ALERT SERVICE BULLETIN
Bell Helicopter **TEXTRON**

NO. 205-05-91

SUBJECT: TAIL ROTOR BLADE P/N 212-010-750-009 THROUGH -129, INSPECTION AND REWORK OF.

HELICOPTERS AFFECTED: Model 205/205A1 Helicopters with Tail Rotor Blades P/N 212-010-750-009 through -129 with Serial Number A or AFS-12700 through A or AFS-14479.

Figure 1: Inspection and Rework Area

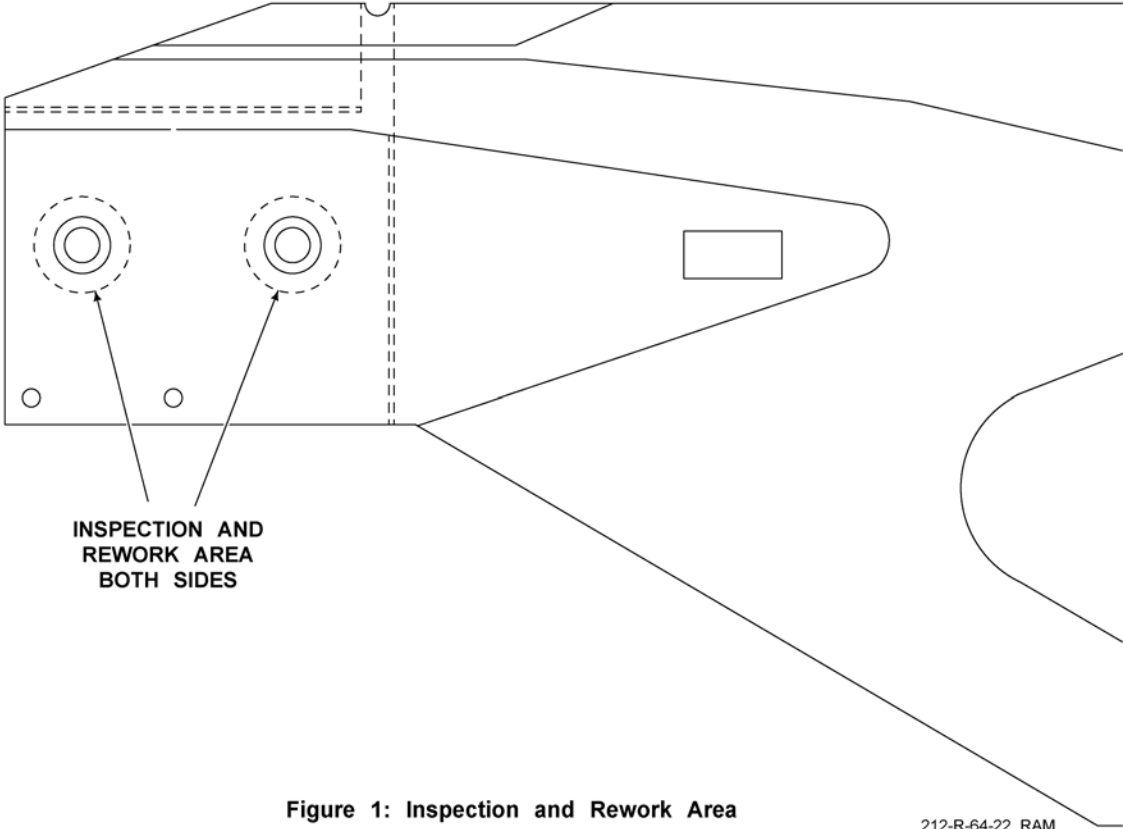
2. Remove paint and adhesive filler in blade bolt washer contact area per Figure 1 using plastic media blasting per the BHT-ALL-SPM.
3. Inspect reworked surface for damage and corrosion. If corrosion is found or damage beyond manual limits, send blade to Bell approved repair facility for repair.
4. Measure depth of spotface on reworked surfaces at all four locations. If depth exceeds 0.035 inches remove blade from service.
5. Apply by brush cleaner (C-344) to the bare metal surface of the reworked area.
6. Thoroughly rinse with water and dry surfaces with a clean dry rag or filtered compressed air.
7. Apply chemical film (C-100) to reworked area.
8. If buffers are damaged, replace per applicable section of CR&O.
9. Refinish blade per CR&O.
10. Install tail rotor blade on aircraft and dynamic balance.
11. Annotate records to indicate compliance with Part II of this bulletin.

Alternate paint and adhesive removal may be accomplished by using a 180 grit cloth or paper and sanding by hand in a spanwise direction only. Surface finish of 32 RMS or better must be accomplished in the rework area after removal of adhesive using 400 grit cloth or paper. Do not remove more than .001" of aluminum material.
